RS-22-020

Clinton Power Station, Unit 1  
Facility Operating License No. NPF-62  
NRC Docket No. 50-461

Subject: Request for License Amendment to Revise the Secondary Containment Design Basis to Credit the Fuel Building Railroad Airlock

**ATTACHMENT 2**  
**Markup of Proposed Updated Safety Analysis Report Pages**

**FIGURE 6.2-132  
SECONDARY CONTAINMENT BOUNDARY  
(SHEET 2 of 6)**

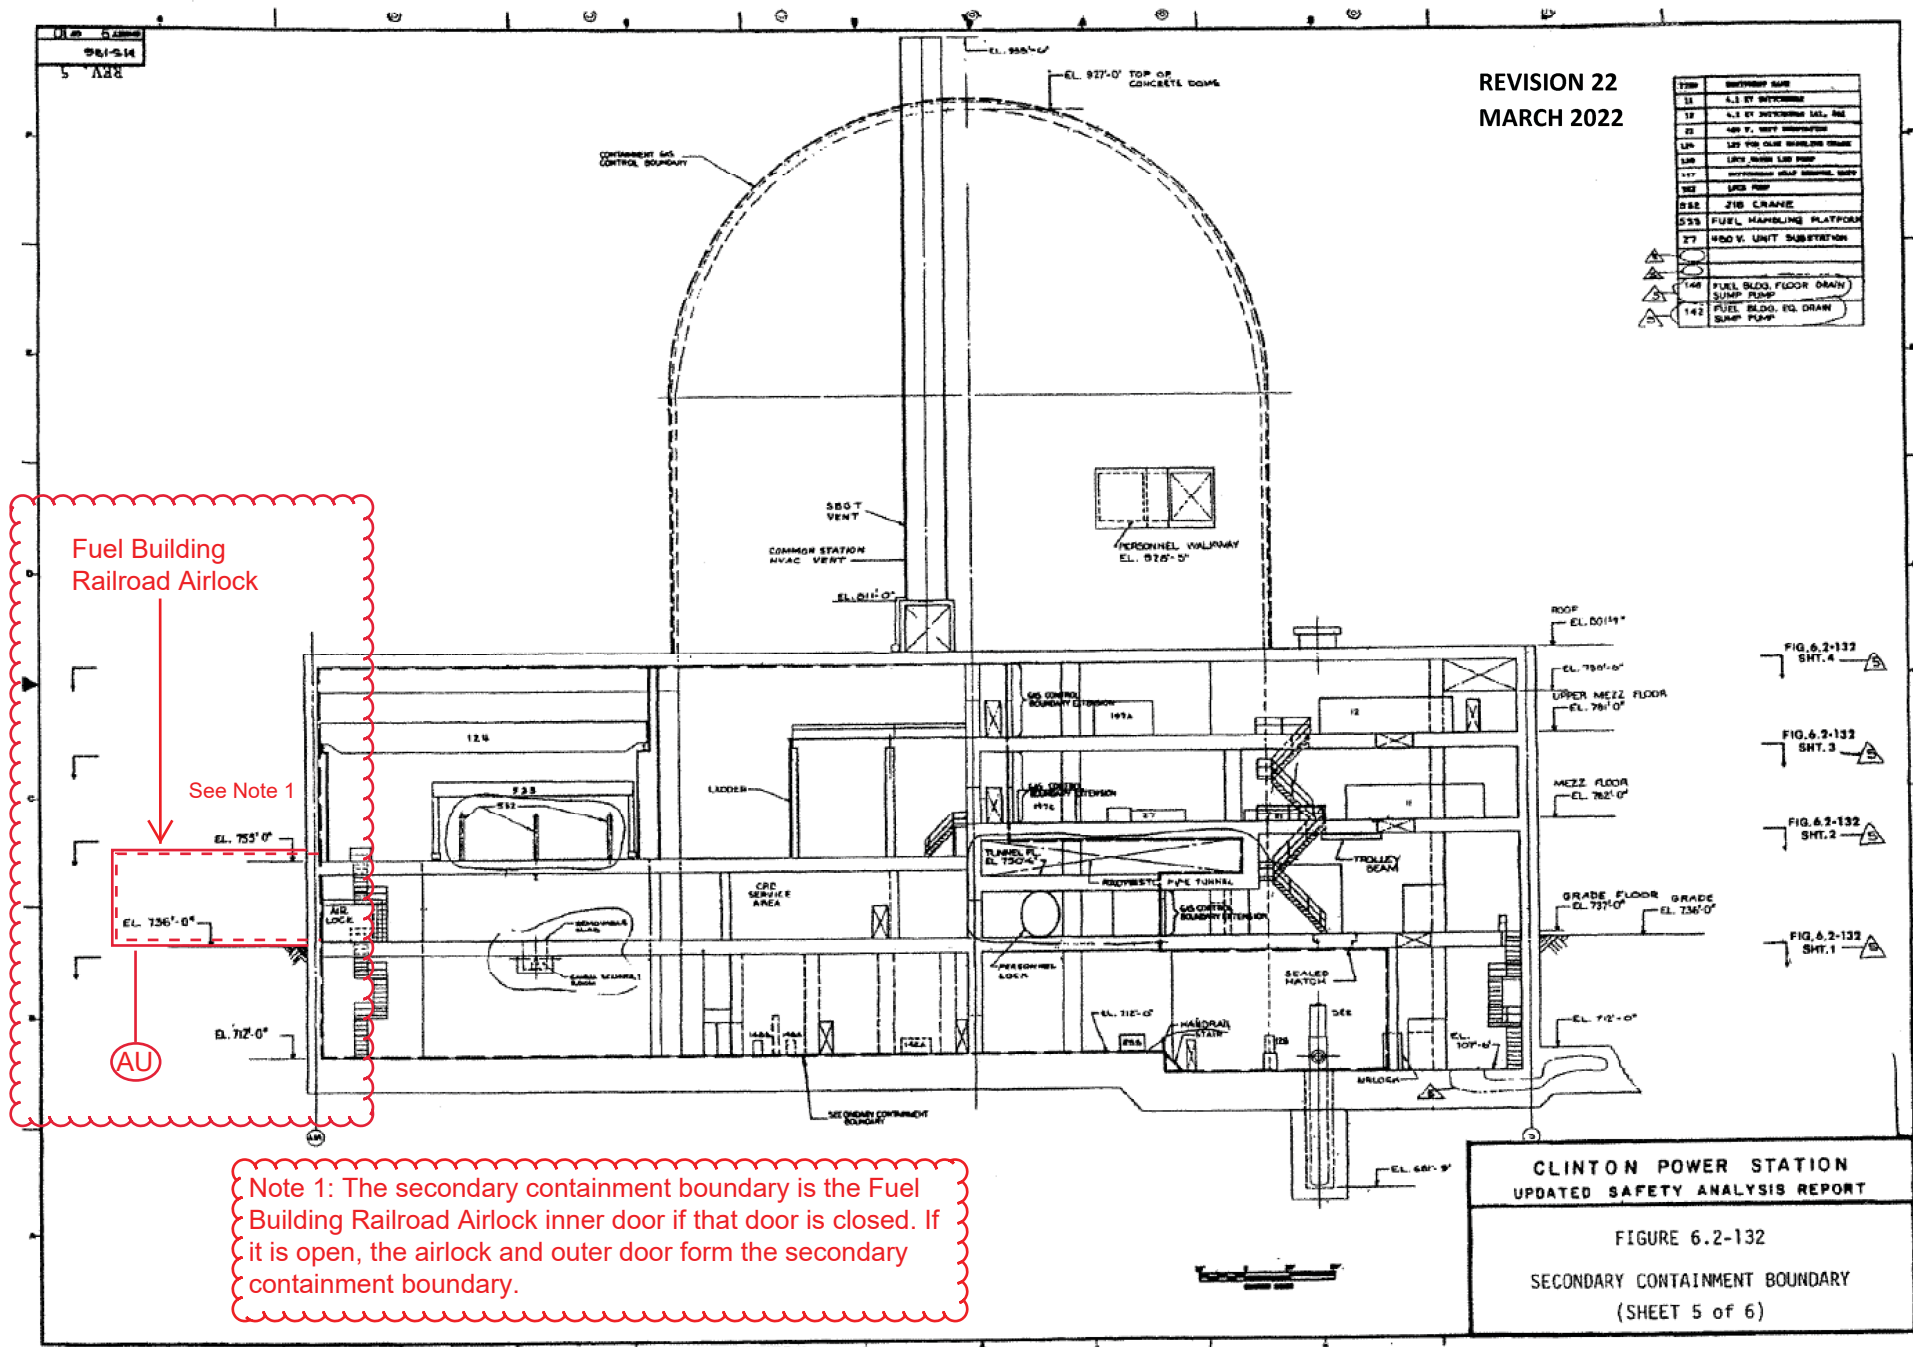
The proposed change revises the secondary containment design basis to extend the secondary containment boundary to include the FBRA. CEG has performed evaluations to verify that the FBRA, including the outer door, meets the requirements for Seismic Category I structures and the secondary containment, except for protection from tornado winds and missiles. The following activities were performed.

Figure 6.2-132 (Sheet 2 of 6)

FIGURE 6.2-132  
SECONDARY CONTAINMENT BOUNDARY  
(SHEET 5 of 6)

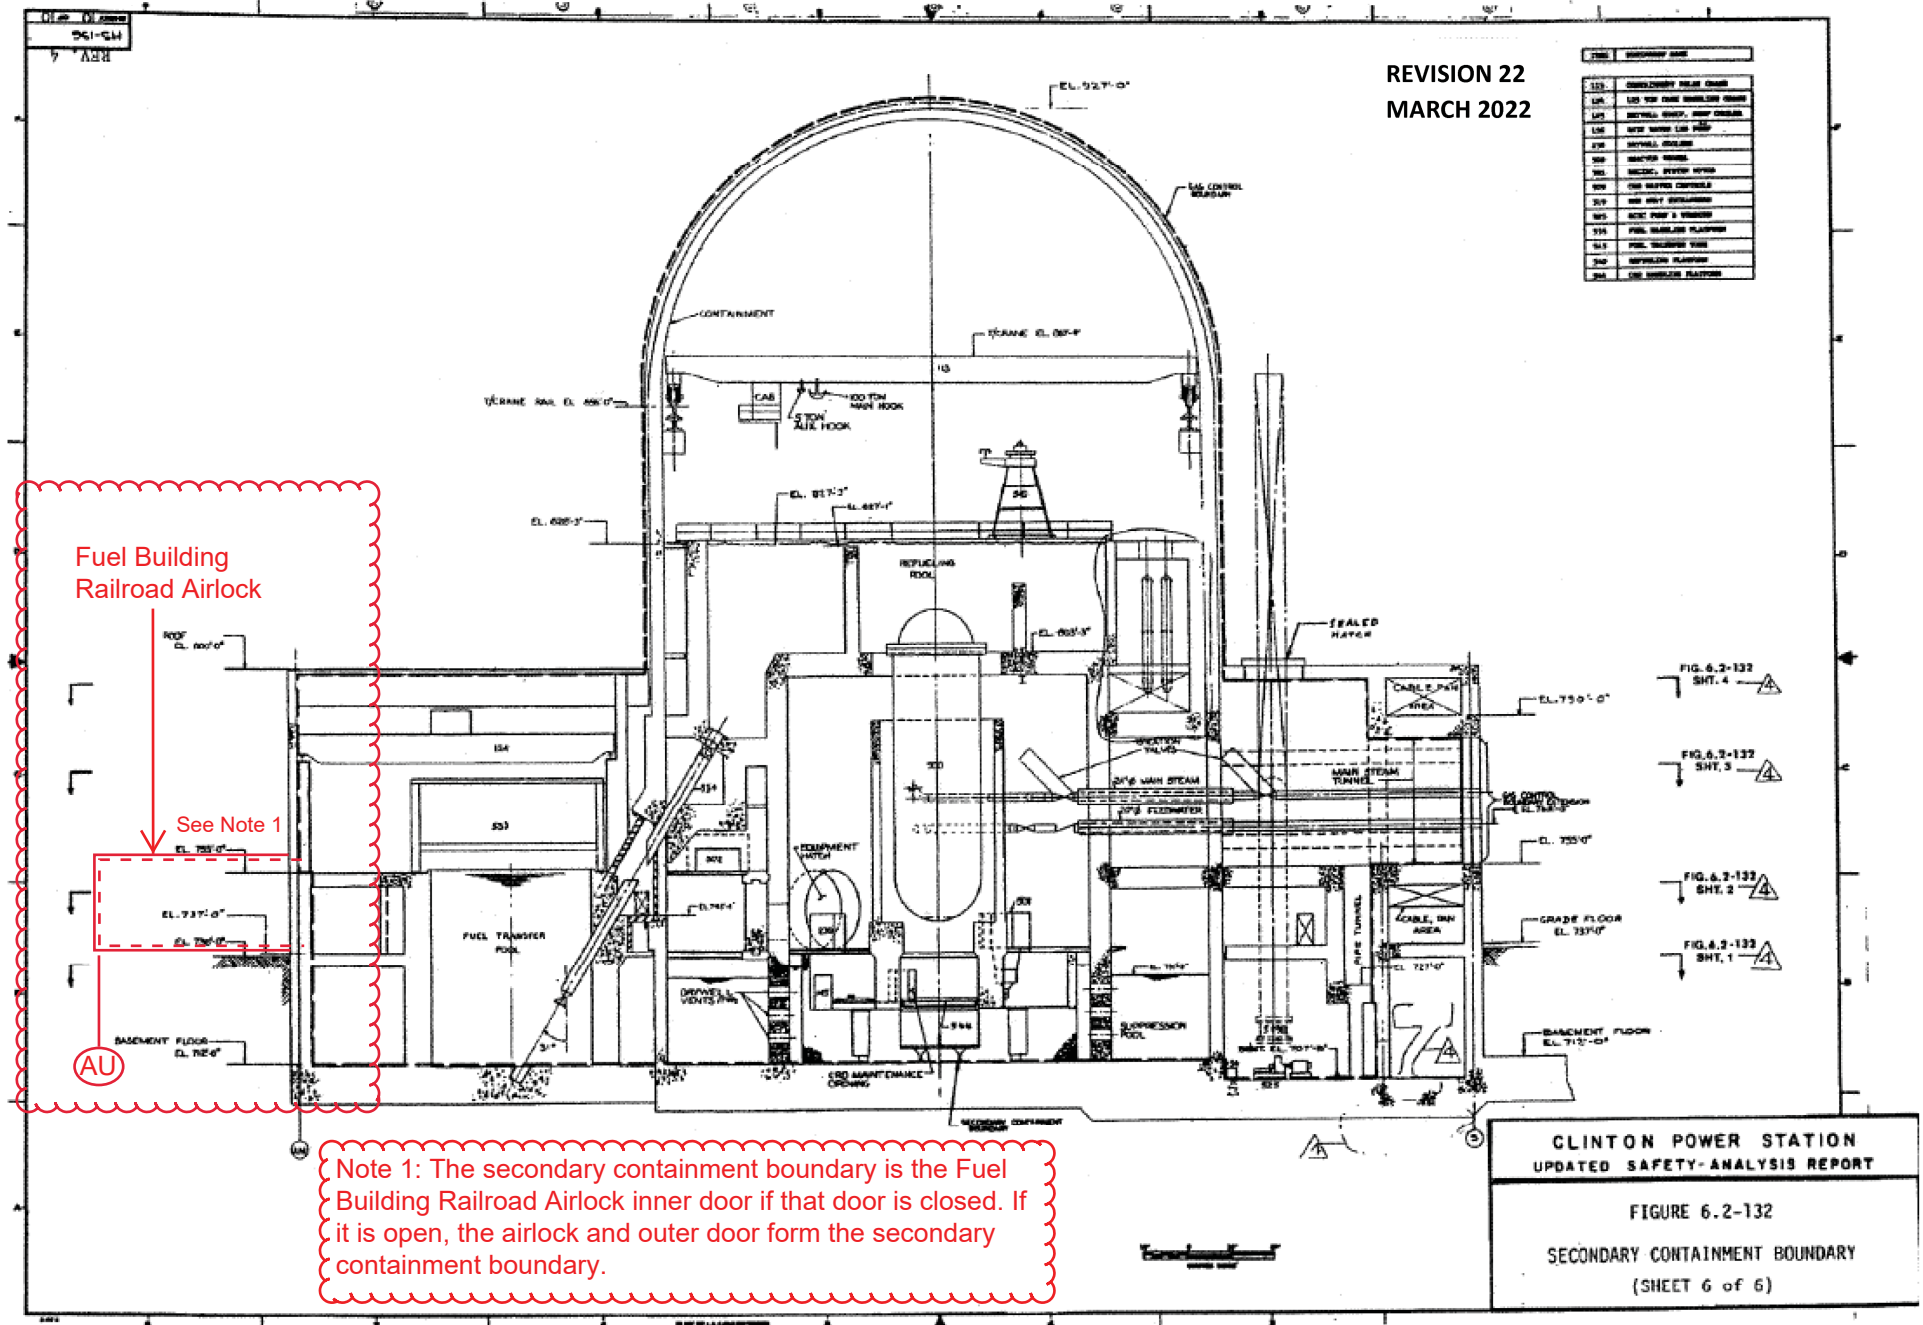
Figure 6.2-132 (Sheet 5 of 6)

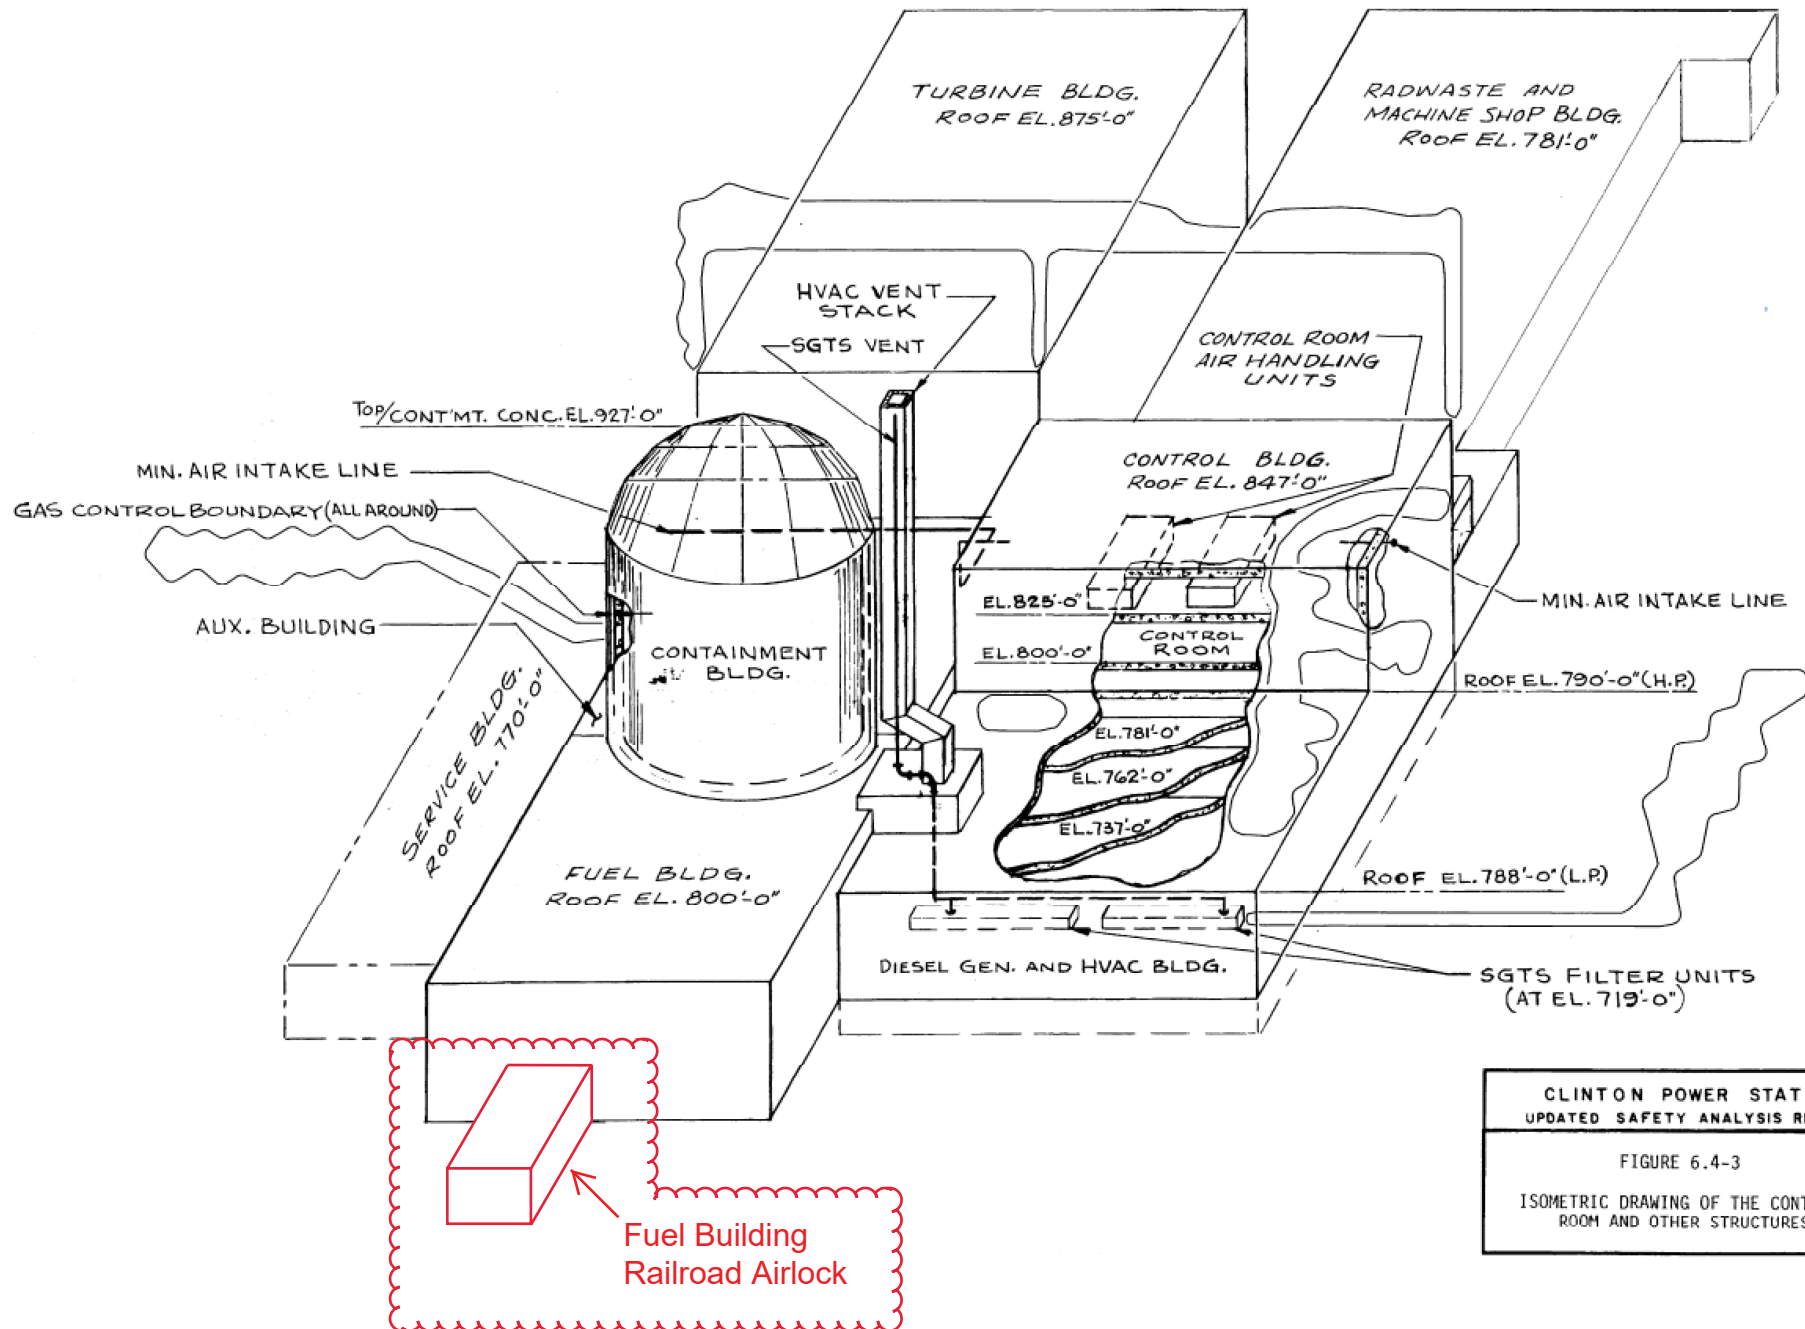
Figure 6.2-132 (Sheet 6 of 6)
